Docket No. UM 2255

IDAHO POWER CORPORATION

2026 All Source Request for Proposals (RFP)

Staff Comments

Figure 2: Load forecast changes between 2021 and 2023 IRP<sup>7</sup>

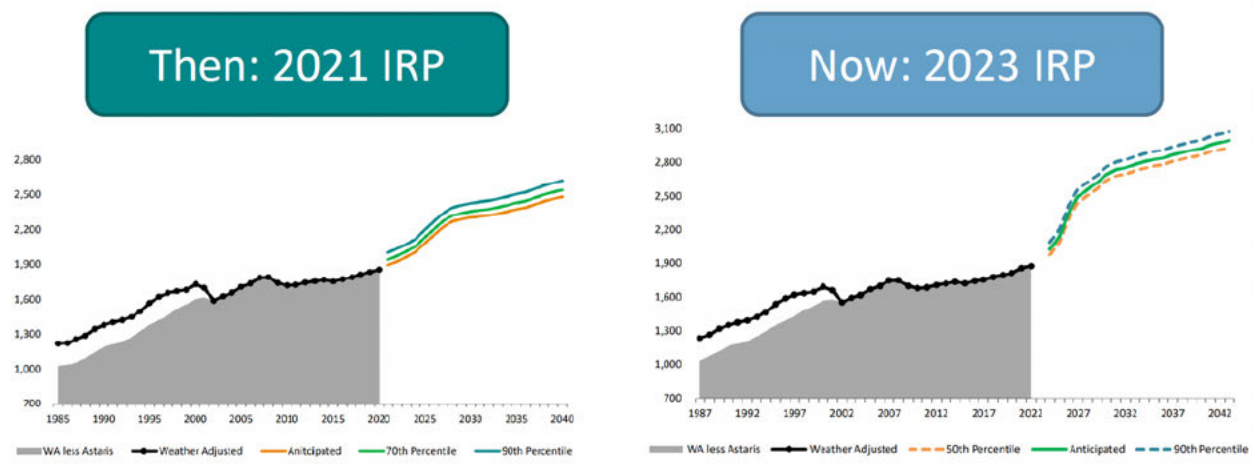
In LC 84, and as shown in Figure 1 below, Idaho Power presents that its load forecast between the 2021 and 2023 IRPs has changed significantly. Were this the only change, understanding need could be straightforward. However, many other key inputs and reliability assumptions have also changed as shown in Table 1 and Table 2, making it difficult for Staff to track documentation supporting identified need.

Figure 3: IPC’s FSL Determination Process – Figure 25 in the IE Closing Report

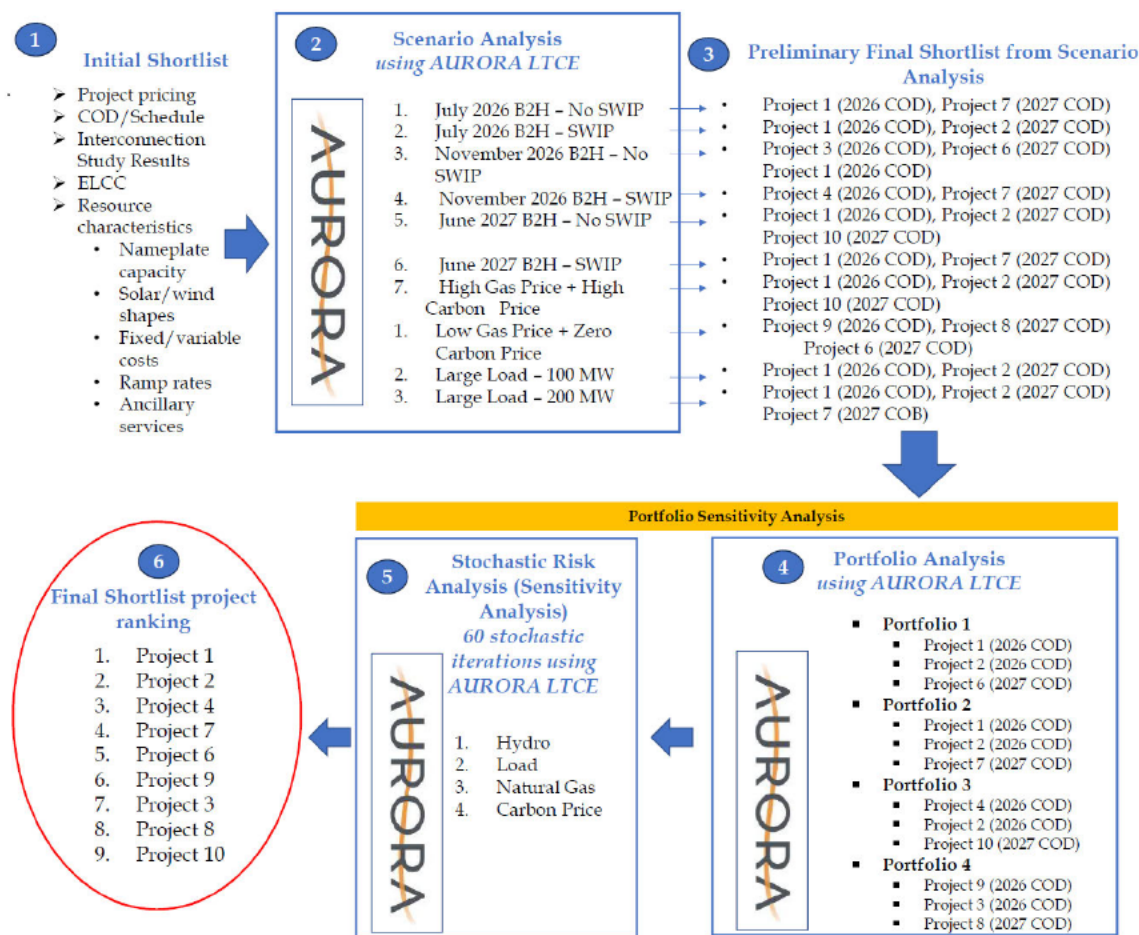
Staff is appreciative of the work of both the Company and the IE in the development and review of each step of this process. Both Staff and the IE are generally comfortable with the overall process that was used to produce and conduct a sensitivity analysis on the FSL. Staff will not go into detail about how the various bids performed throughout the process, as that is provided in detail in the IE Closing Report attached to the FSL filing. However, Staff has questions about the application of the new Effective Load Carrying Capability (ELCC) approach in the development of the ISL, which are addressed further in the Section on the Price and non-Price Scoring, below.
